ADDENDUM NO. 1

PROJECT NAME: NEBRASKA SOCCER & TENNIS COMPLEX - SOCCER FIELD
UNL PROJECT NUMBER: C909P101
BID INVITATION NUMBER: 2268-13-7200

CONSULTANT: OLSSON ASSOCIATES, INC.
ADDRESS: 1111 LINCOLN MALL, SUITE 111, LINCOLN, NE 68508

DATE OF ISSUANCE: WEDNESDAY, NOVEMBER 20, 2013
DATE OF BID OPENING: TUESDAY, NOVEMBER 26, 2013

SITE STAGING PLAN

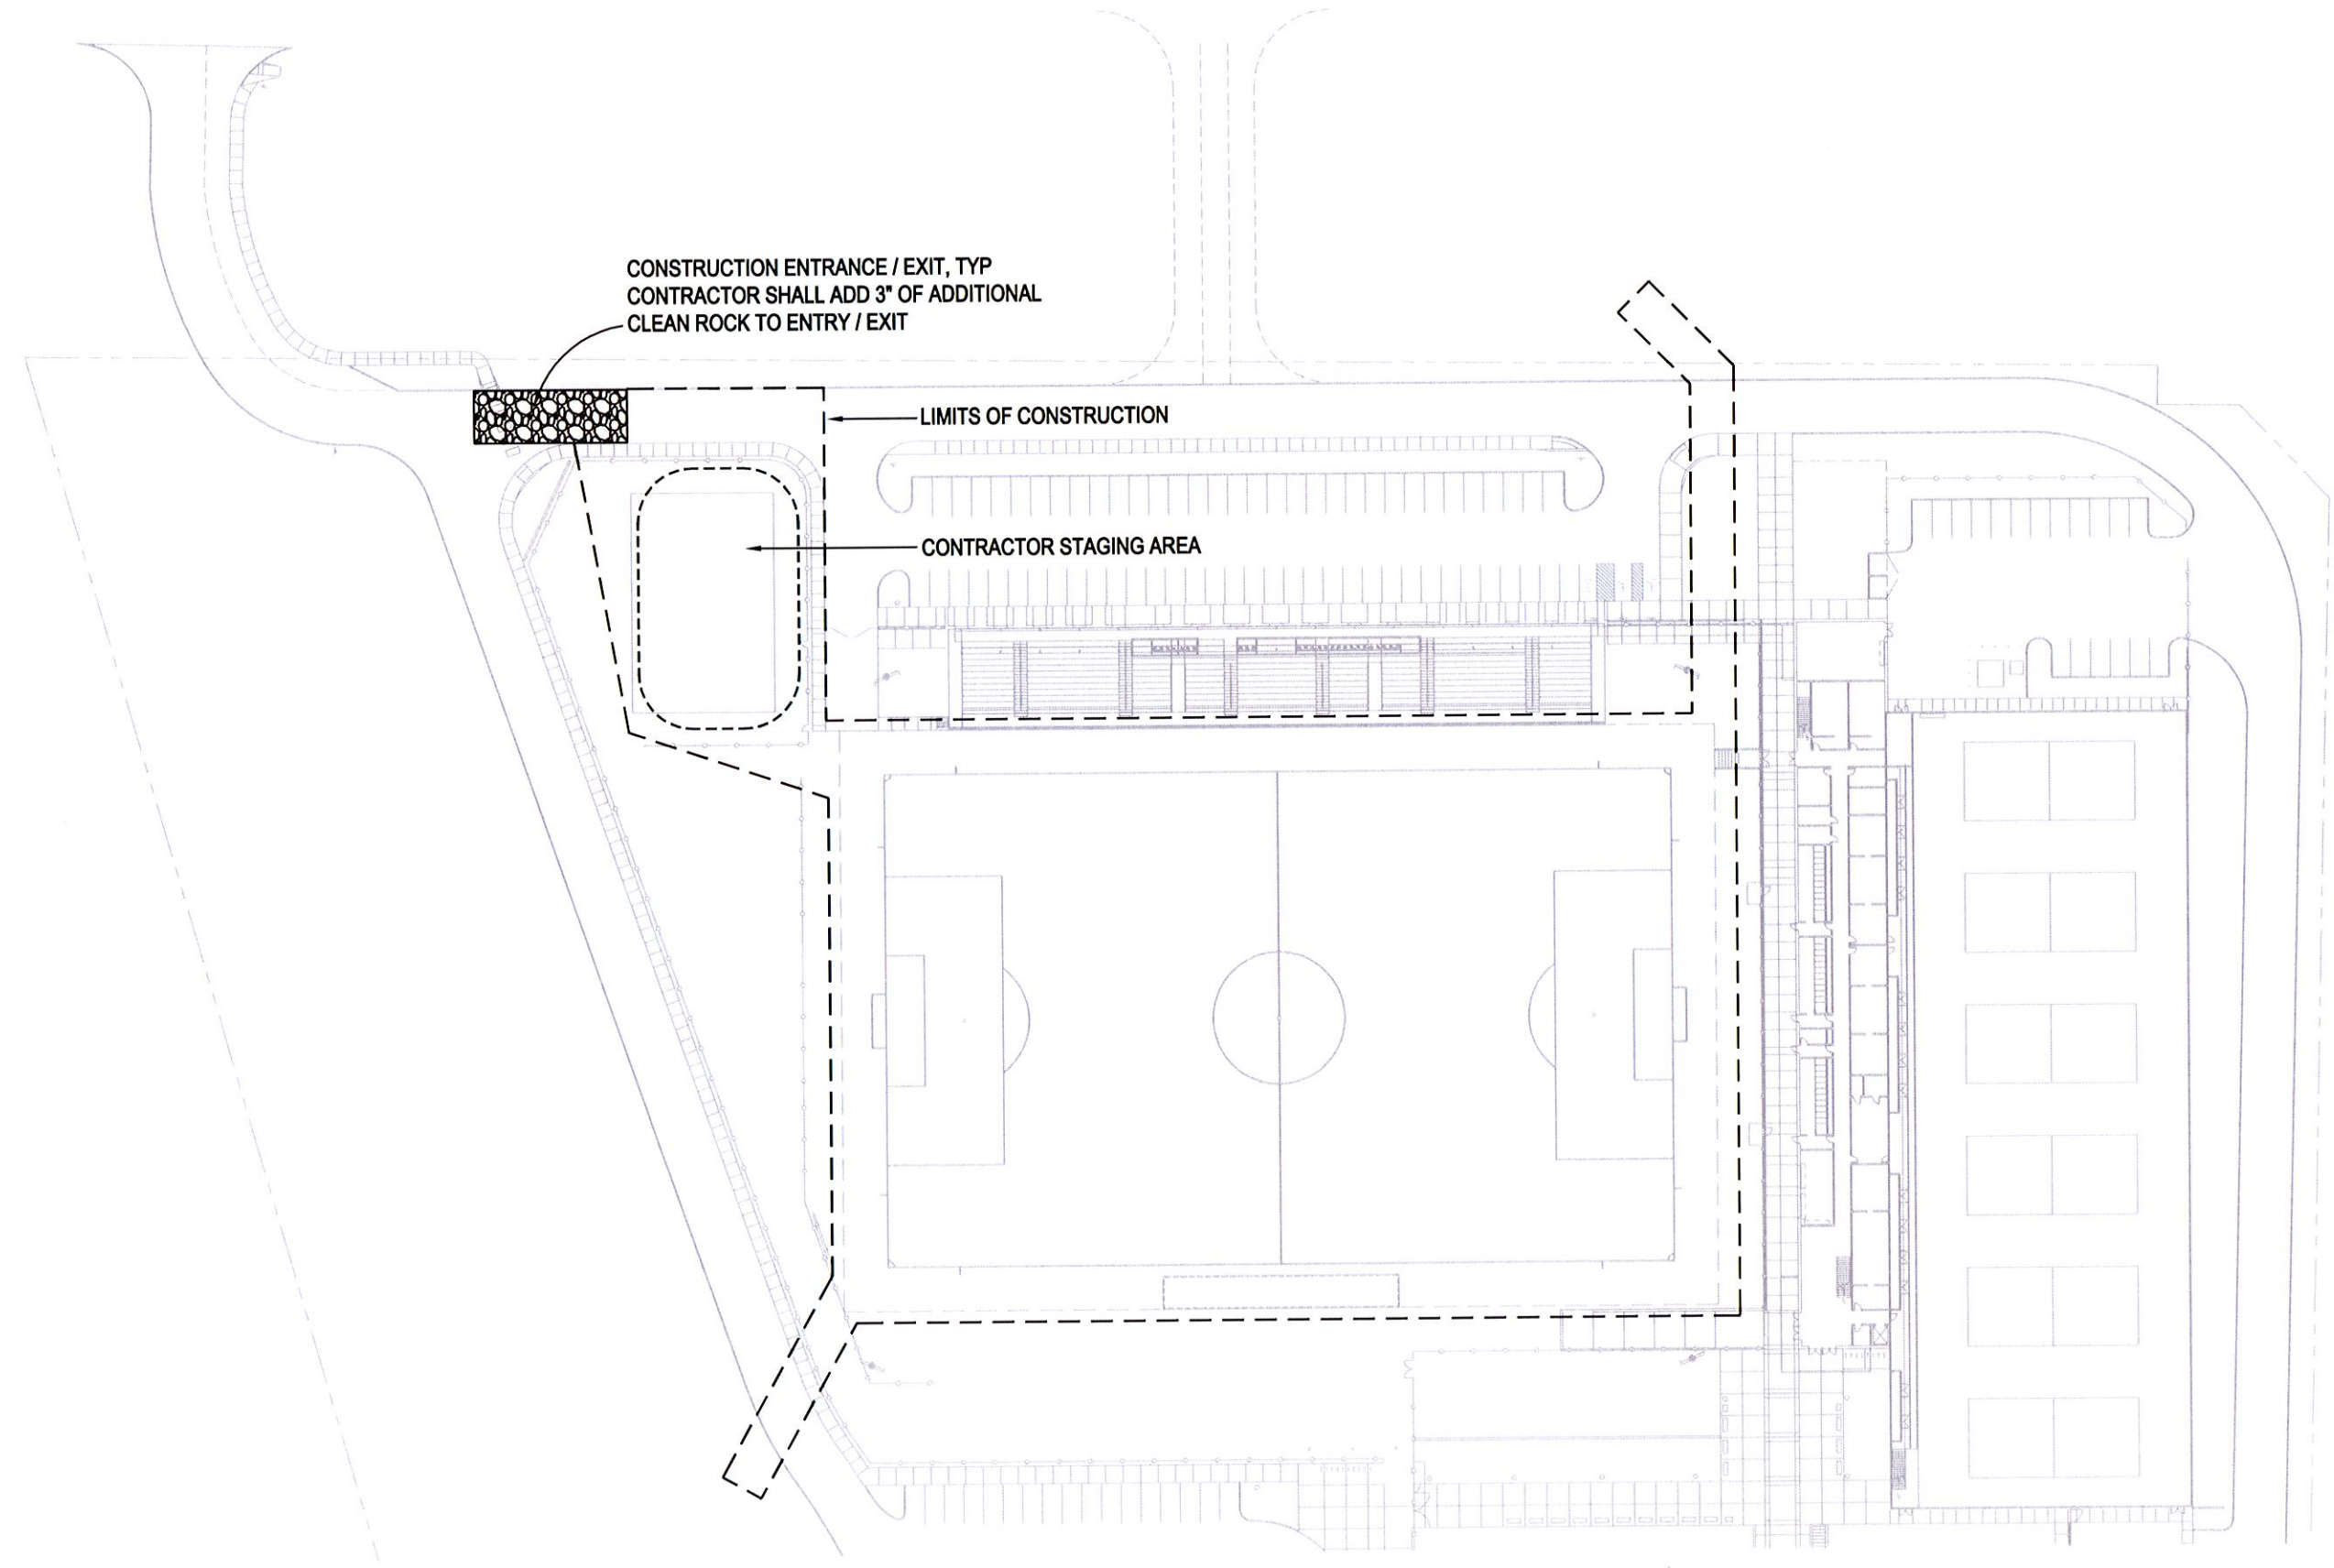
1. Refer to Drawing No. SDL07 for site staging and limits of construction requirements.
